TOWN OF MONUMENT 2.0 MG WATER STORAGE TANK

MONUMENT COLORADO

90% SUBMITTAL

Site Development Plan _V2 combined redlines.pdf Markup Summary 1-27-2022

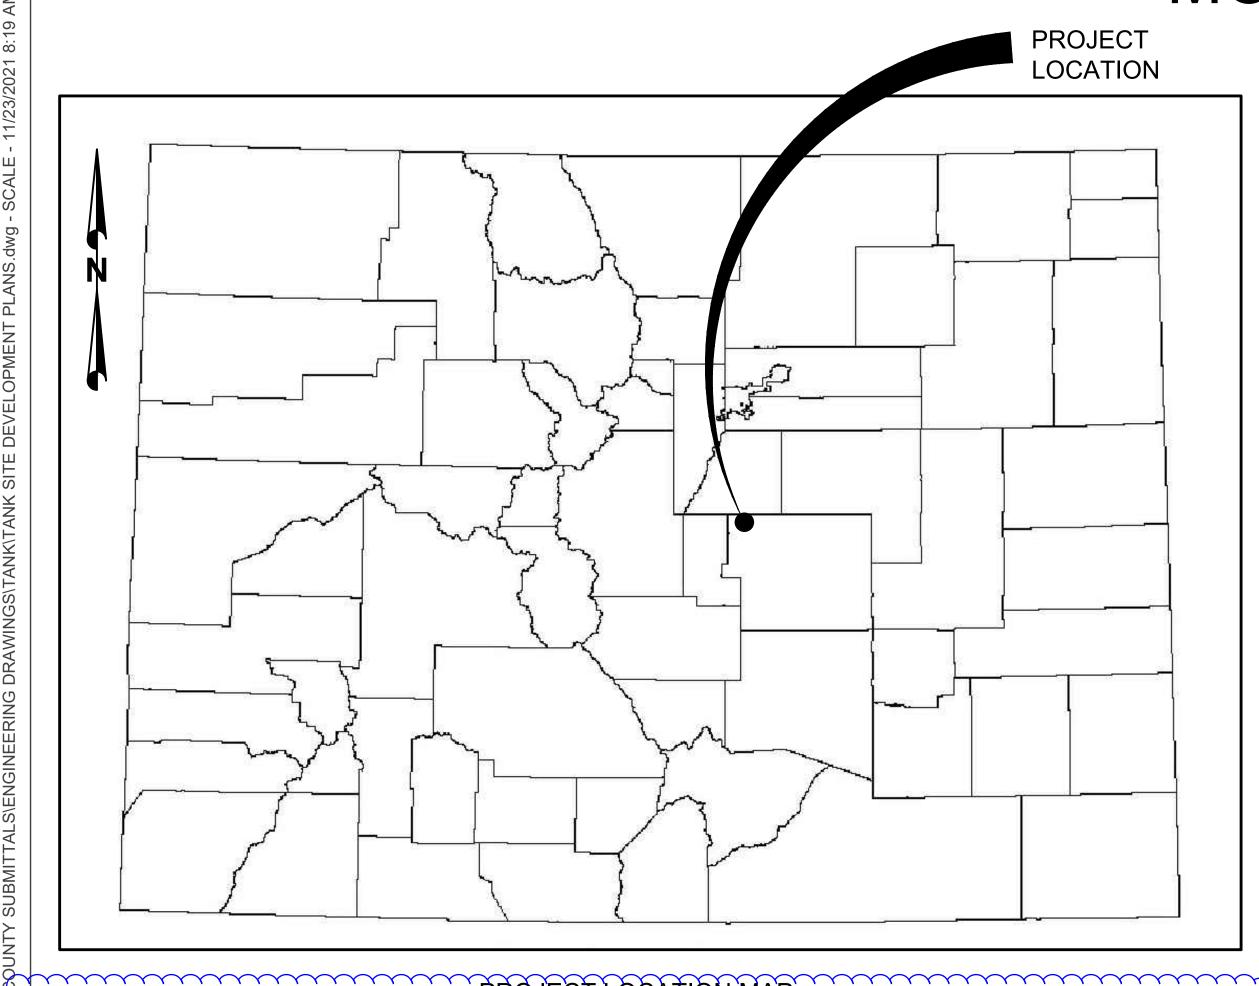
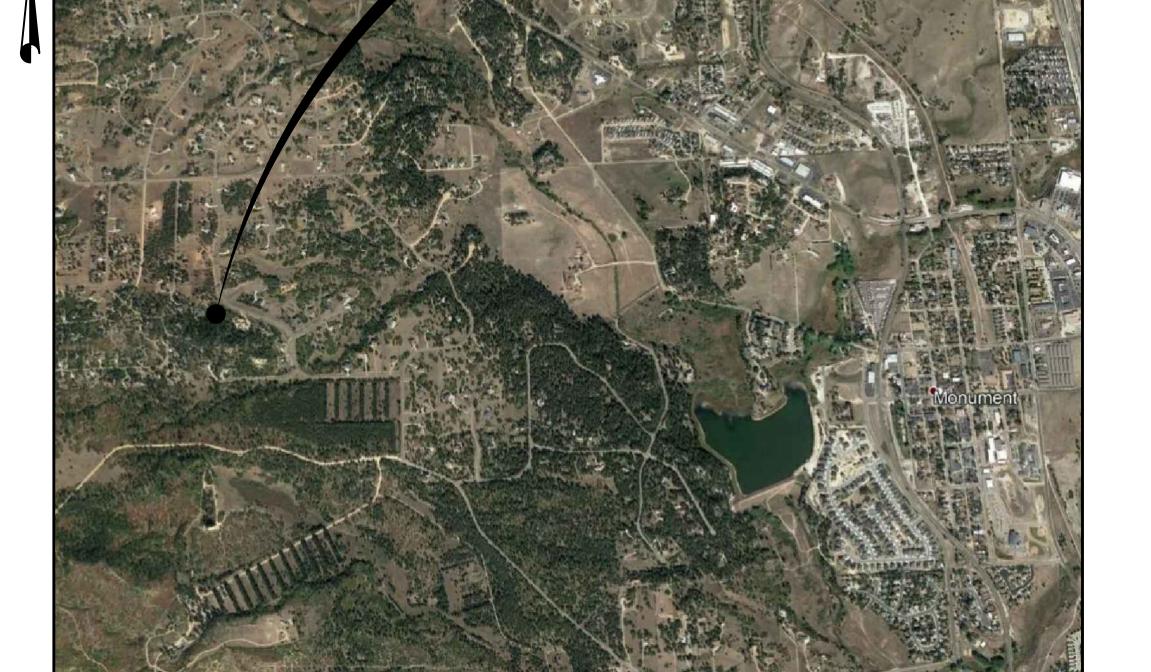
ease remove these signature blocks from the site evelopment plan. The engineering manager does not pprove construction drawings (line CDs) under a site relopment plan. You can label construction plans in this ocument as "reference only" since the construction rawings will be reviewed for approval.

delete this... this a submittal for approval ..Add the file number to the plans in lower corner; PCD file PPR 21 30

Status: Color: Layer: Space: County Wide Traffic Fee Program- BOCC RES 19-471will apply to this project at the time of building permit. Please contact Victoria Chavez for the fee required to be paid at building permit for

the tank site.

SHEET NO: **TS 101**

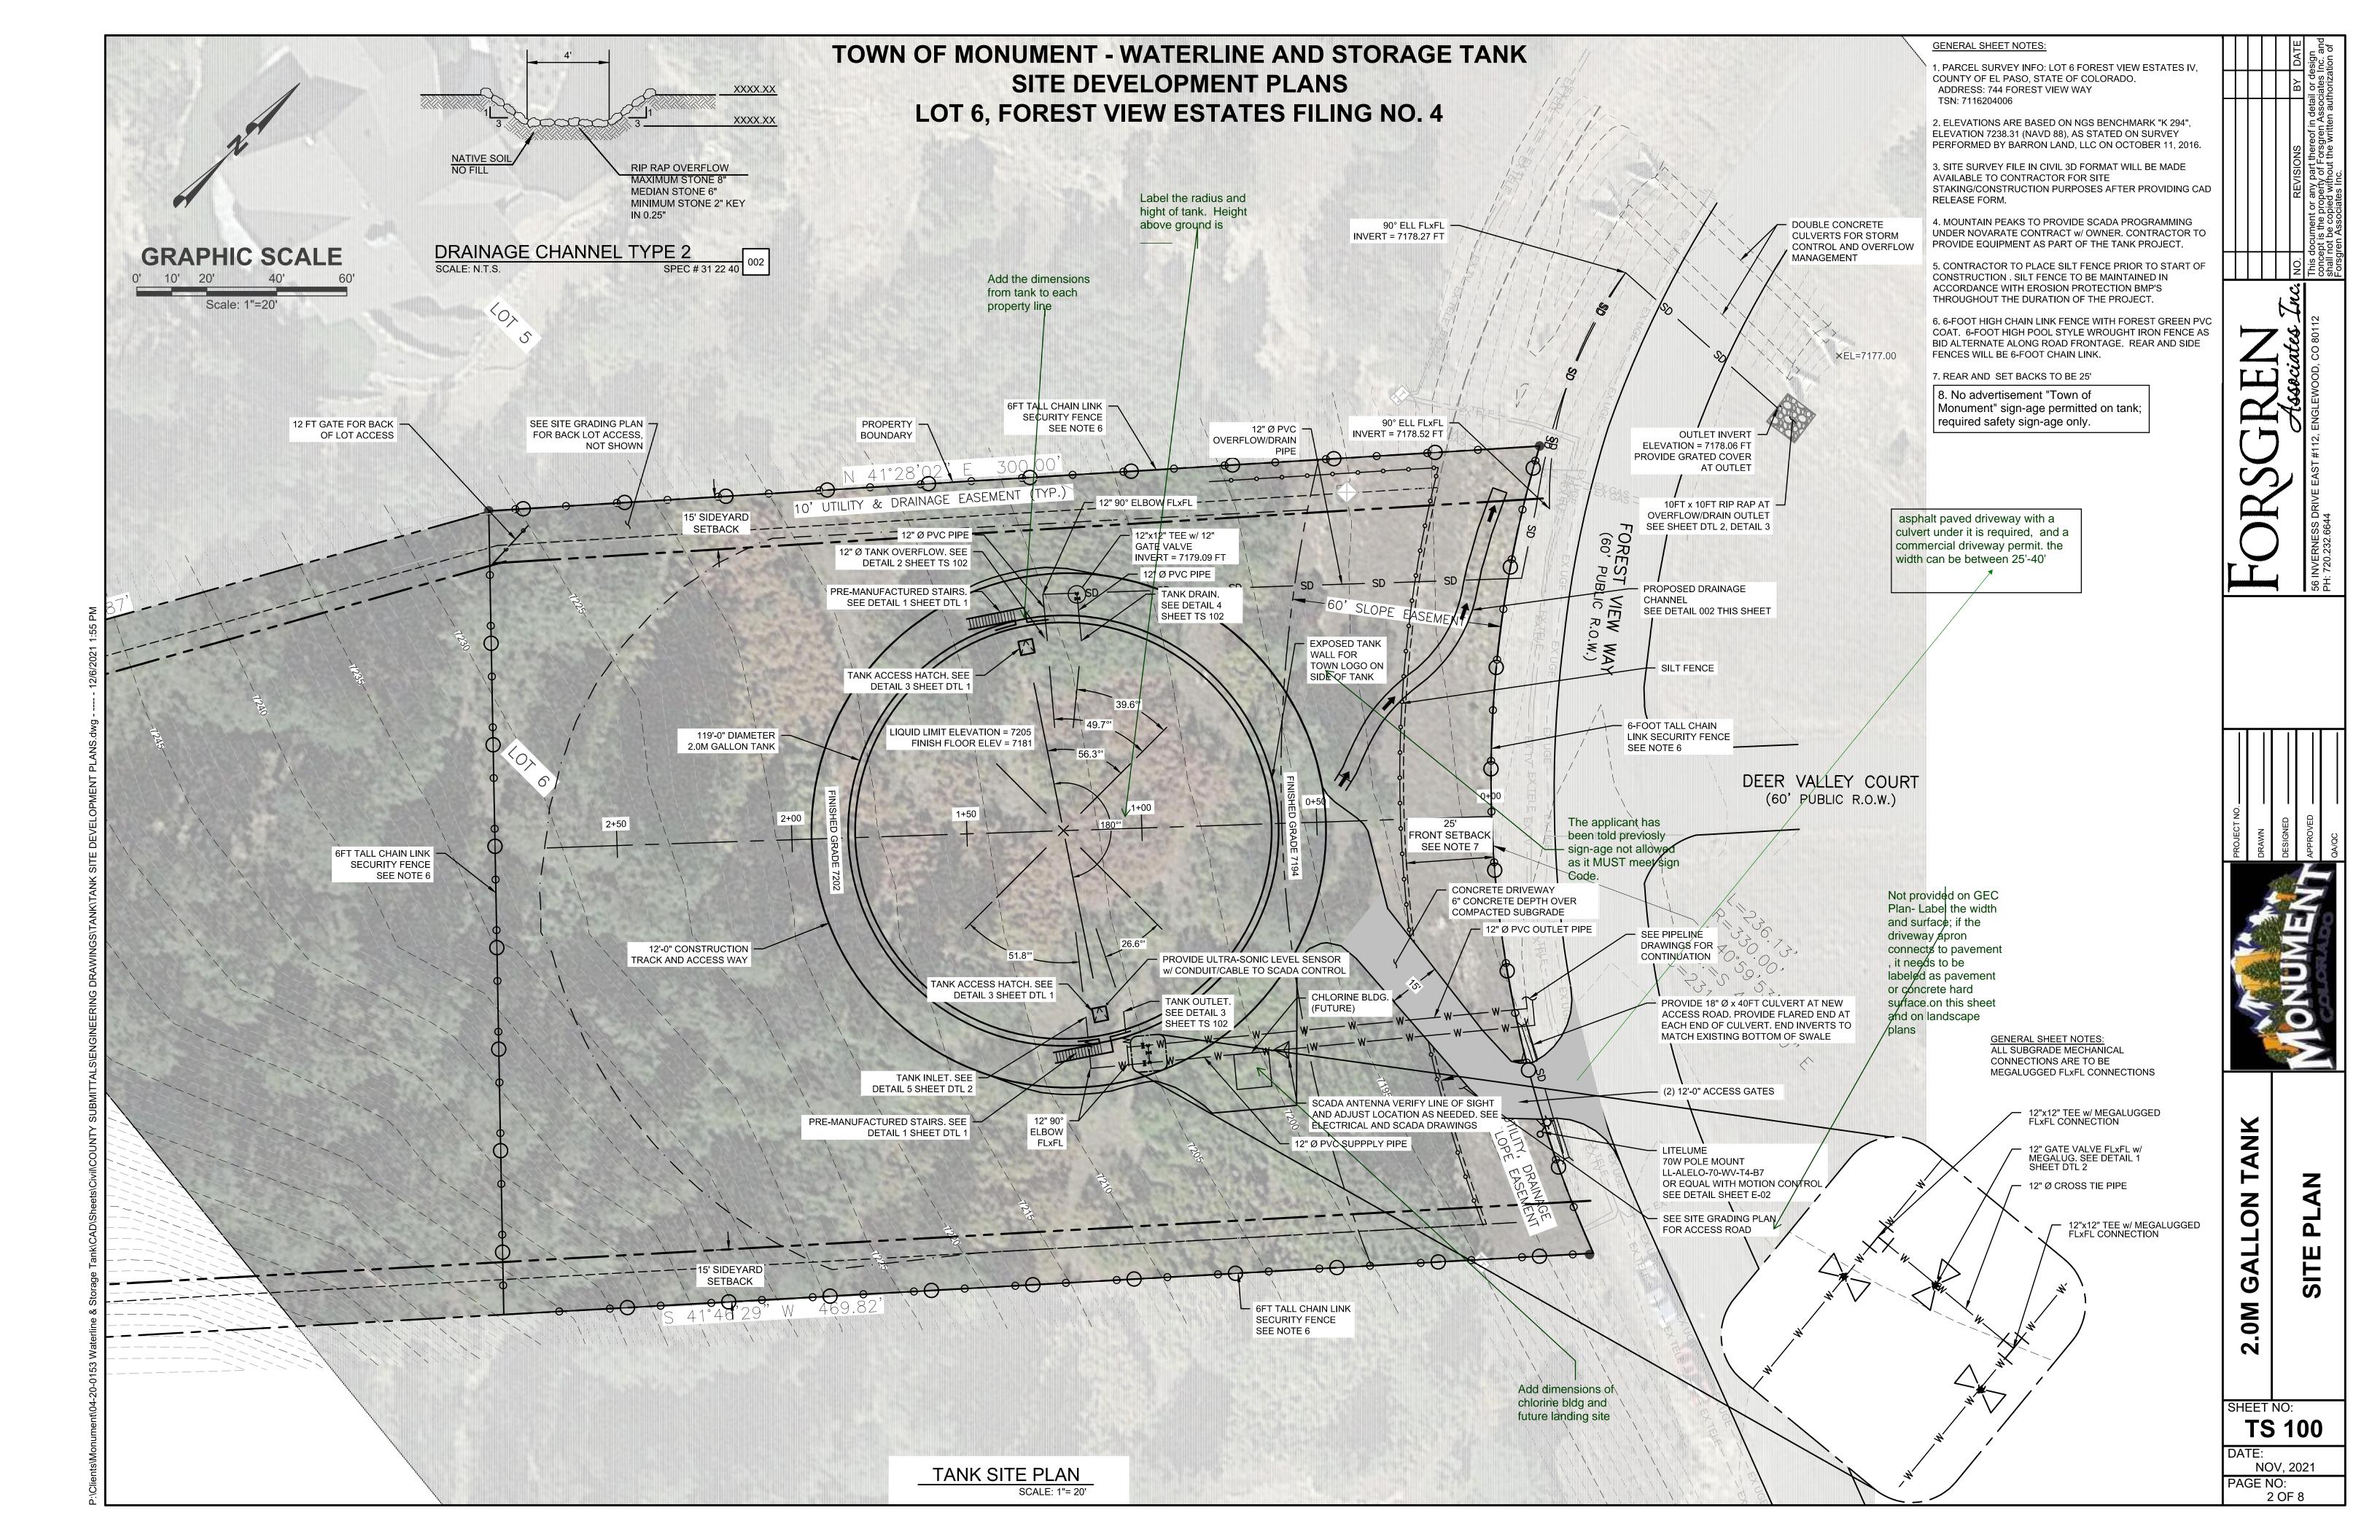
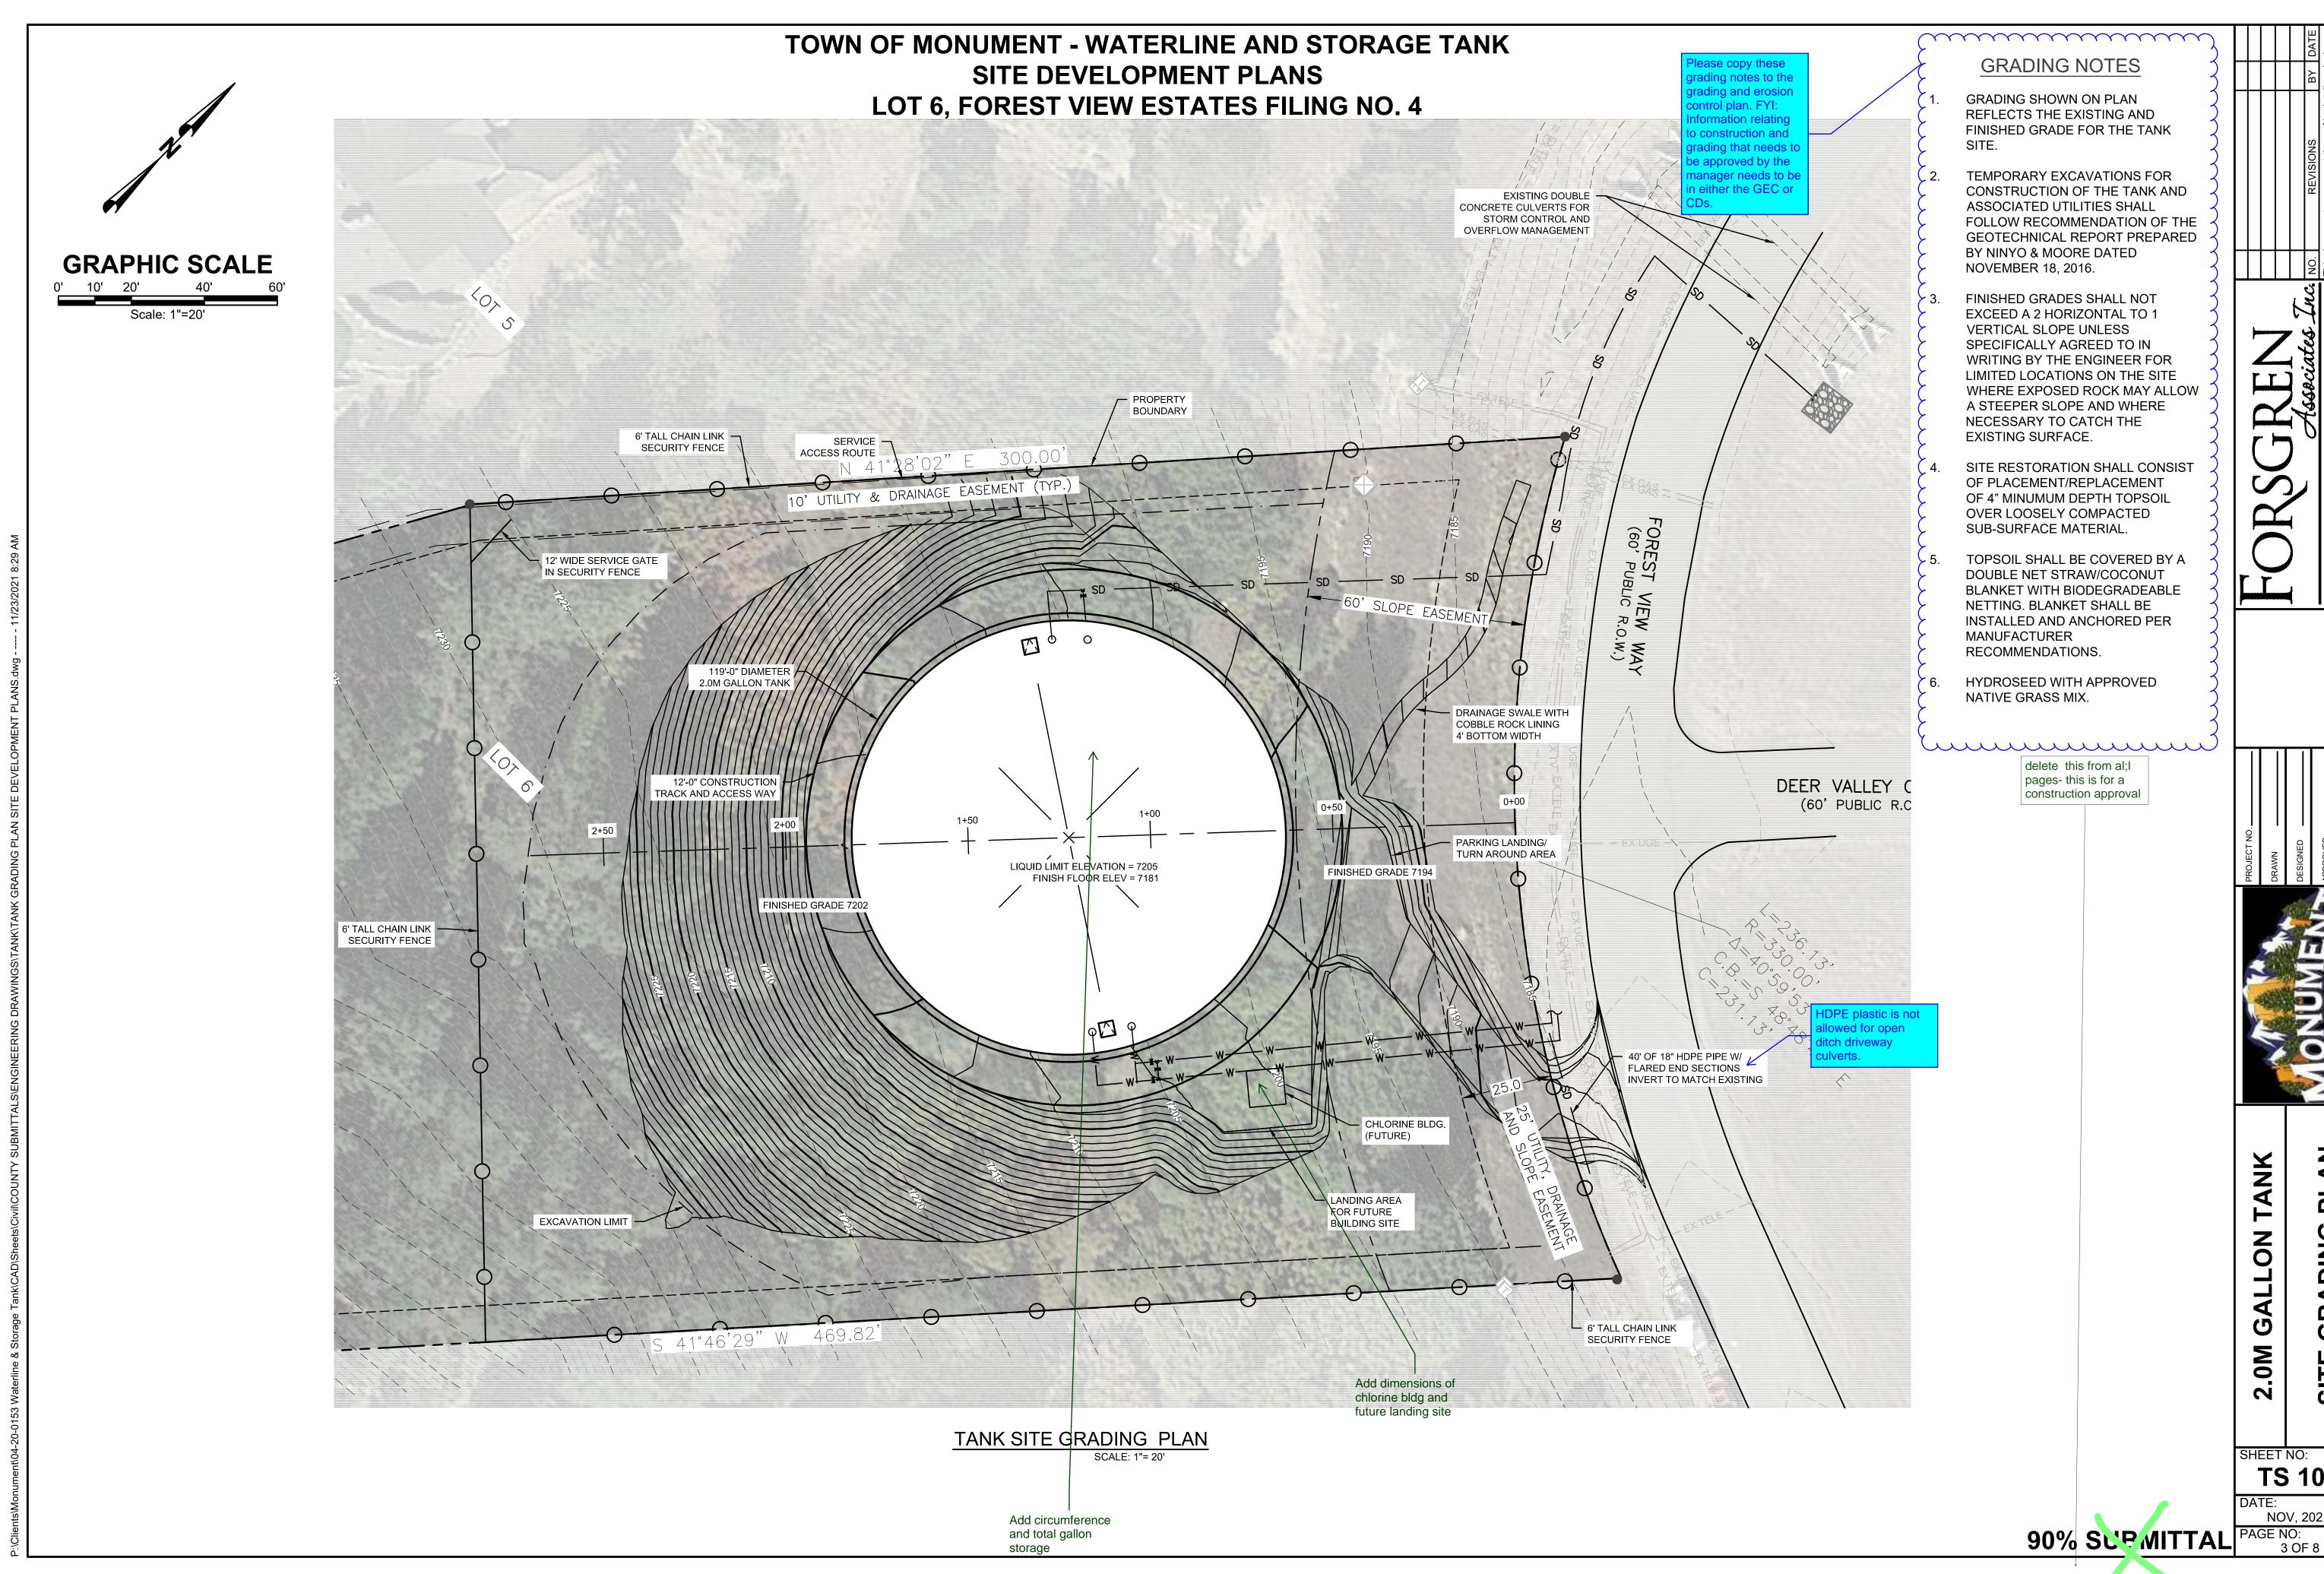
Status: Color: Layer: Space: Add the dimensions from tank to each property line

Status: Color: ■ Layer: Space: Add dimensions of chlorine bldg and future landing

Status: Color: ■ Layer: Space: Not provided on GEC Plan- Label the width and surface; if the driveway apron connects to pavement, it needs to be labeled as pavement or concrete hard surface.on this sheet and on

landscape plans

6. FLOOT HER CONN. LIKE FEINE WITH FOREST GREE CONT. 8-600 THIS PIROR STITL WEROUGHT BON FREE BO ALTERNATE ALONG ROAD FROMTAGE. REAR AND S FENDES WILL BE FOOT CHAM LIKE. 7. REAR AND SET BACKS TO BE 25° B. No advertisement Town of Monrument's gin-age permitted on tank; required safety sign-age only. Subject: Text Box Page Label: 2 Author: dsdparsons Date: 1/18/2022 3:12:40 PM

Status: Color: ■ Layer: Space: asphalt paved driveway with a culvert under it is required, and a commercial driveway permit. the

width can be between 25'-40'
